MISSISSIPPI RIVER-GULF OUTLET, LOUISIANA

GENERAL DESIGN MEMORANDUM NO. 2
SUPPLEMENT NO. 3
BAYOU LA LOUIRE RESERVATION

February 1968

SUBJECT: Mississippi River-Gulf Outlet, La., General Design Memorandum
No. 2, Supplement No. 3, Bayou La Loutre Reservation

TYPICAL SECTION WALKWAY FENDER
Scale: 1/2" = 1'-0"

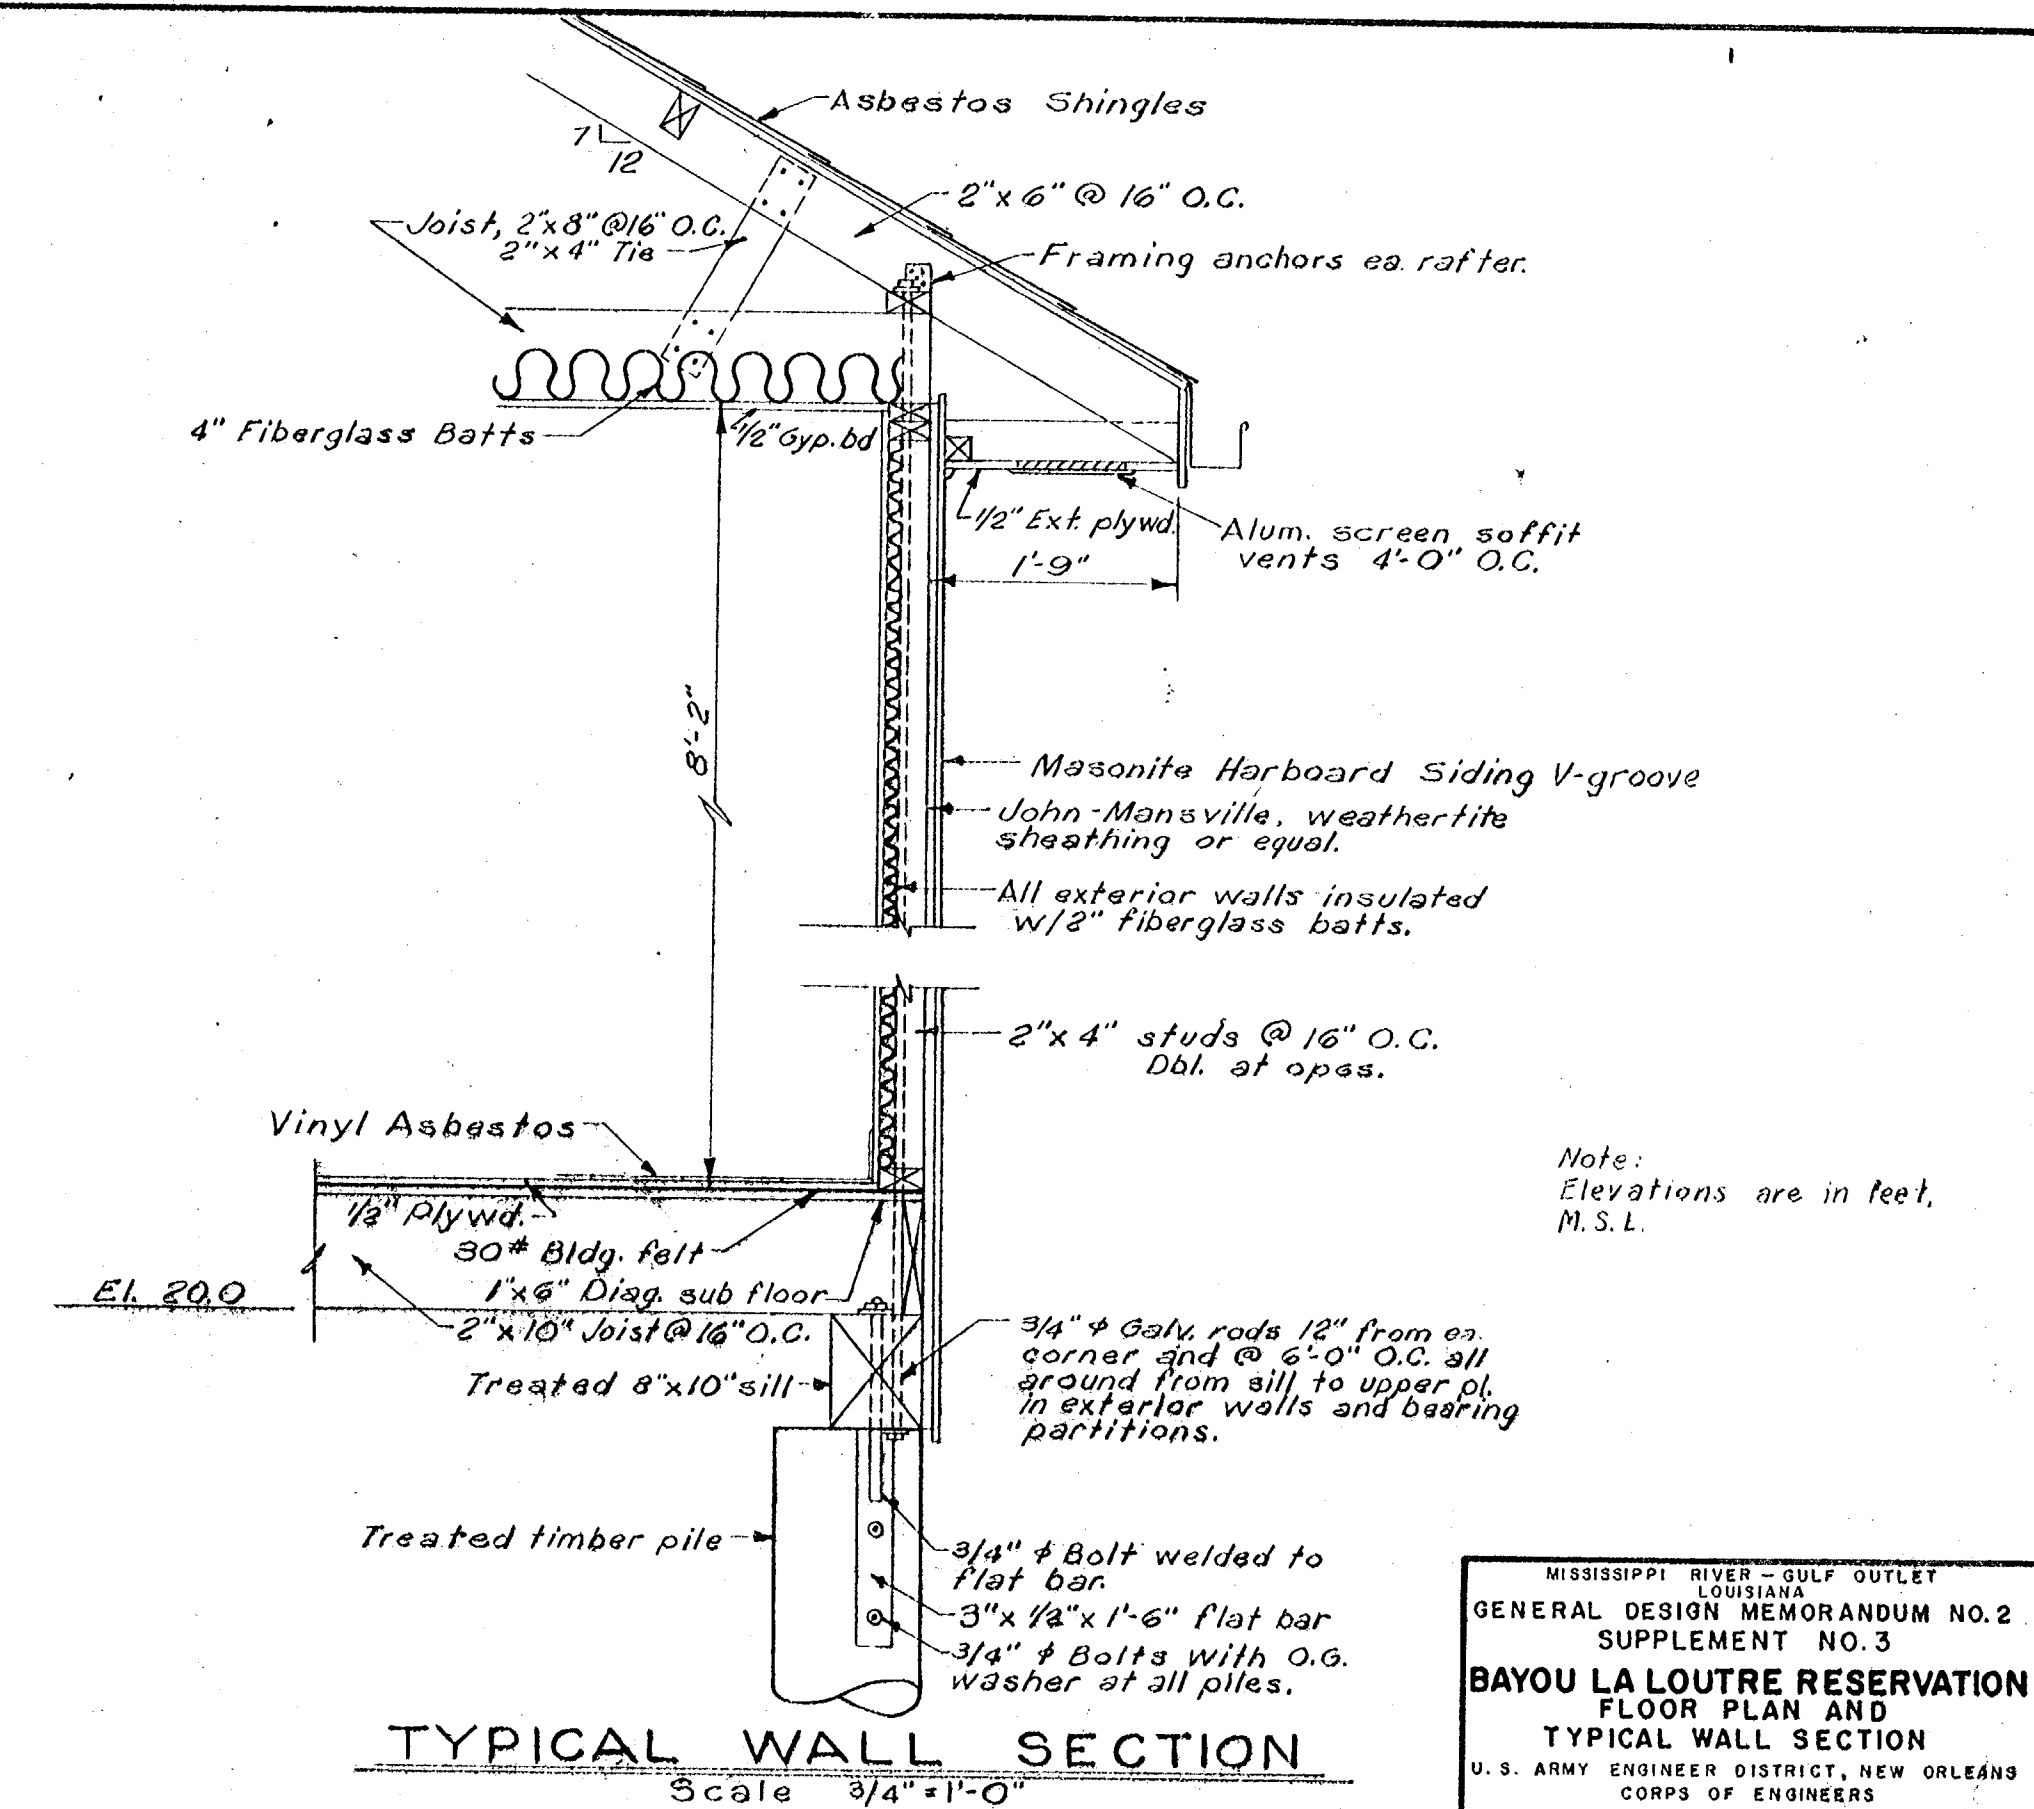
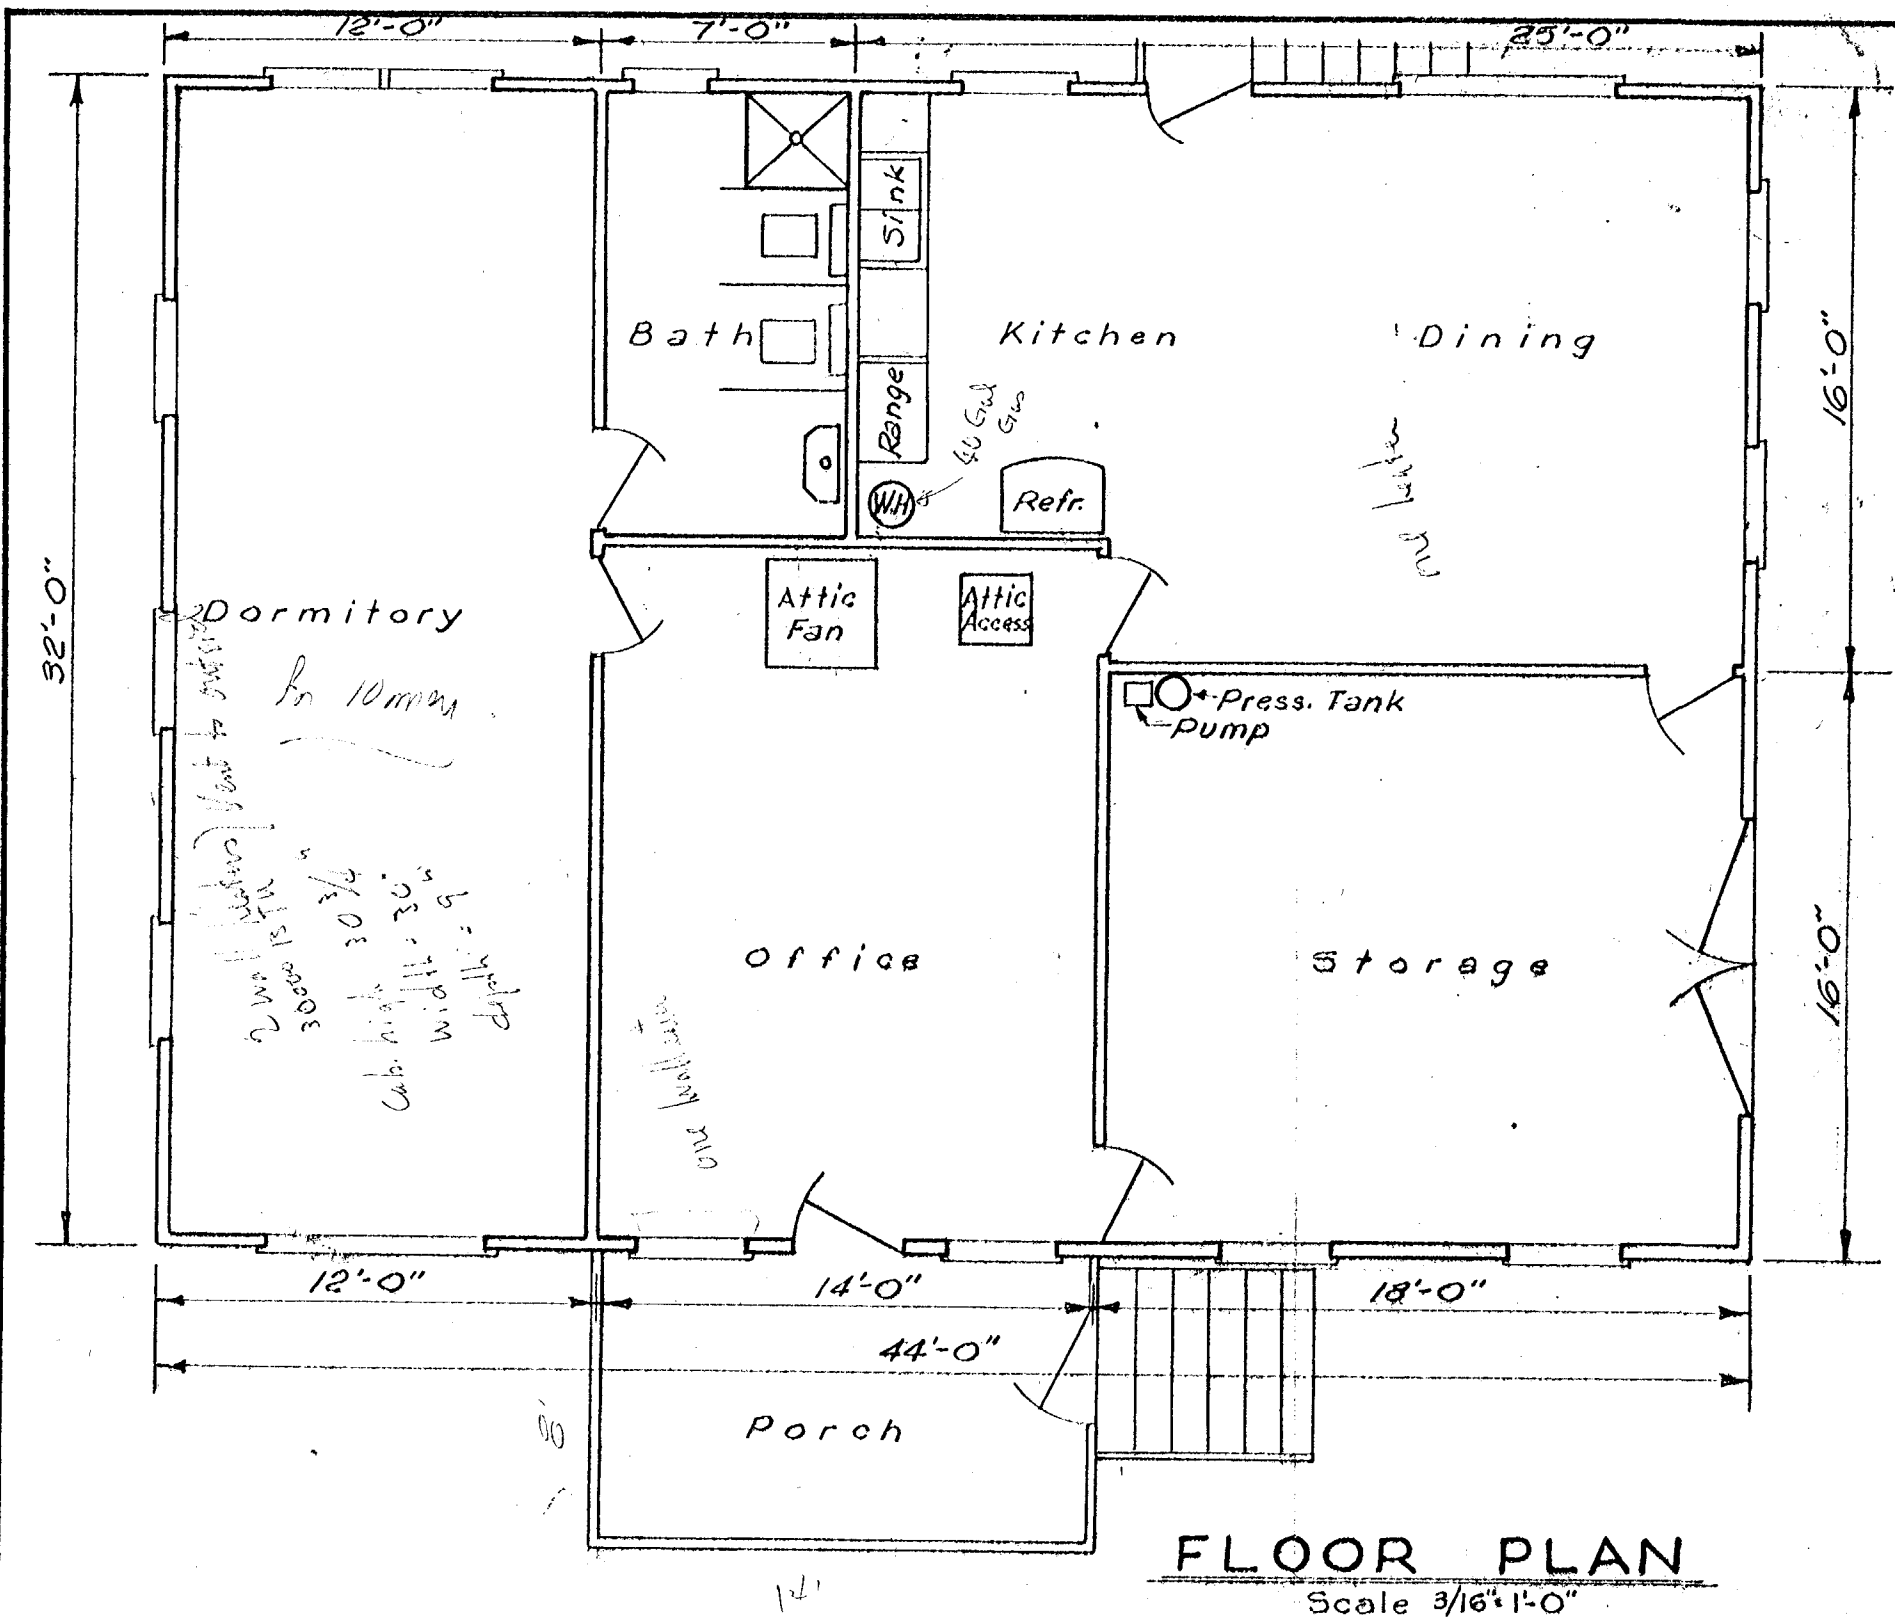
6. Plate IV-4. a. Additional study should be made of the typical bent framing. The effectiveness of the cross bracing is limited to the strength of the bolted connections which will be weakened by the spacer blocks required at most connections to permit assembly. Also, the width of the cross bracing members need not be greater than as required to develop the connections.

b. Consideration should be given to eliminating the diagonal cross bracing and providing a thrust member between the two 3 x 8's bearing on the piles so that the thrust transferred between piles will not be limited to the strength of the bolted connection.

6. Plate IV-4. The diagonal cross bracing has been eliminated and a thrust member provided. The cost estimate has been revised accordingly. A typical section through the timber bent is attached (inclosure 6).
